APPLICATION REPORT - PA/056624/09

Planning Committee, 5 August, 2009

Application Reference: PA/056624/09
Type of Application: Outline Planning Permission

Proposal: Outline application for the erection of a Metrolink Stop. Access and layout to be considered, all other matters reserved.

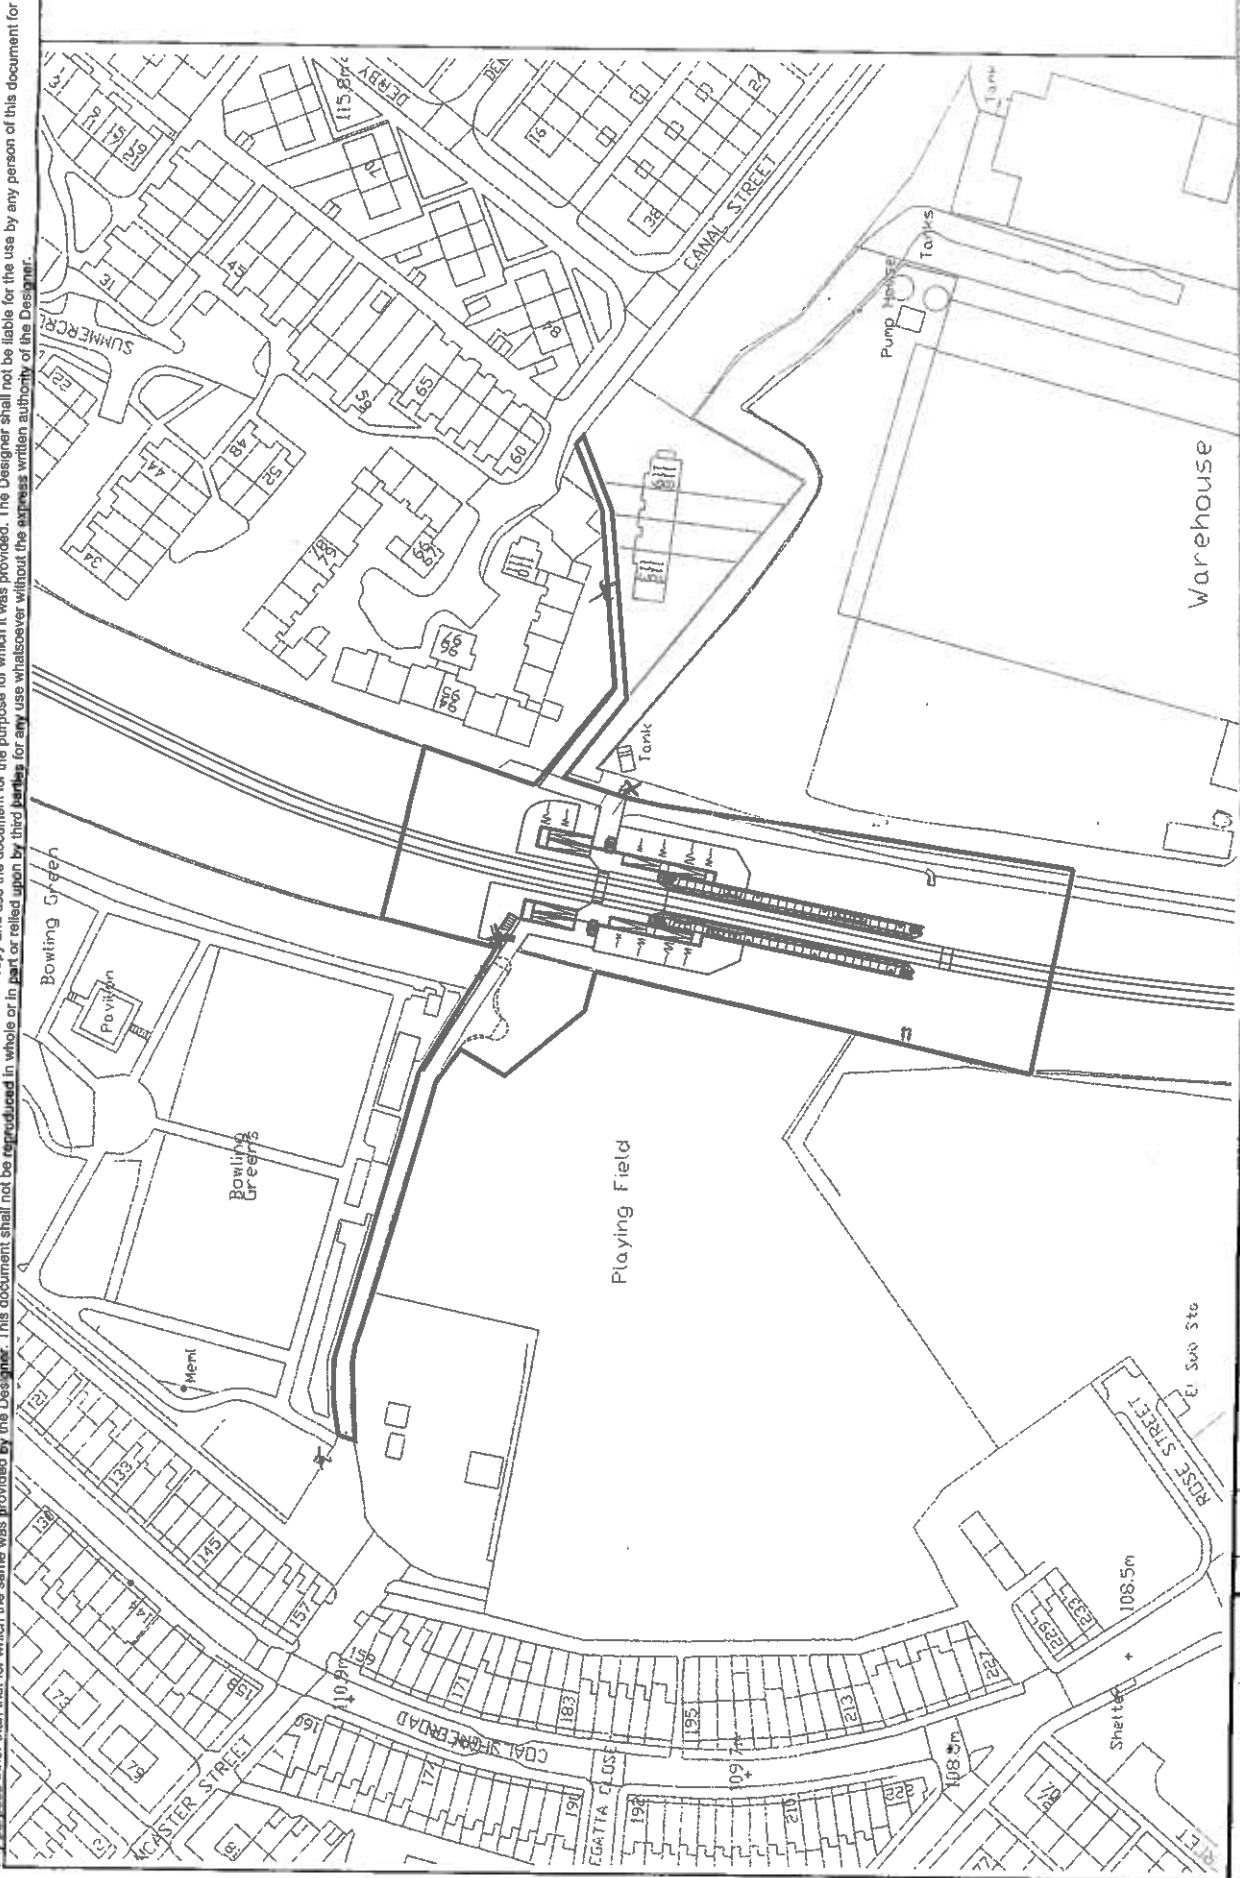
9. Notwithstanding submitted drawing no. MPT3A-OR3-21-LDP-681 Rev PO2, no development shall take place unless and until a pedestrian access detail to the neighbouring Rose Mill residential development site has been submitted to and approved in writing by the Local Planning Authority. The access detail shall be implemented thereafter in full accordance with the agreed scheme and prior to the commencement of the use, unless agreed otherwise in writing by the Local Planning Authority.

Reason: To provide direct and inclusive access from the development site to the proposed station..
